PM8200,PS17, Date: 16-July-2002 Model: SR8200,SR9200 marantz[®] Page: 1/1 REF.NBR: MZ02-013 **SERVICE** BULLETIN Subject: Circulation: Application: In correct a RELAY part was used. x for information customer complaint in case of service mandatory See Below Int.ref:

[PHENOMENON]

Incorrect parts mixed and were used.

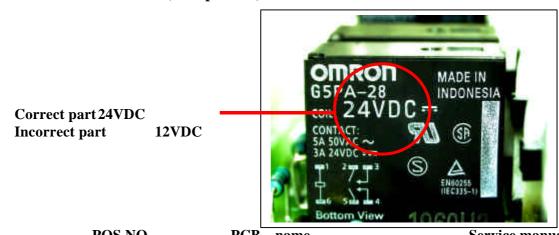
PUS.NU.	PCD name	Service manual
PM8200	L701	P101-MAIN CIRCUIT BOAD	page 9 and page 10
PS17	LB03/ LB04	PB04-BACK UP SUPPLY CIRCUIT BOARD	page32
SR8200	LP91	P124-SPK OUTS FRONT SURRBACK	page71
		HEAD CIRCUIT BOARD	
SR9200	LP91	P124-SPK OUTS FRONT SURRBACK	page71
		HEAD CIRCUIT BOARD

Please exchange for the correct the part.

Correct part no 9965 000 05895 (PCS part no) LY20240490 (MJI part no)
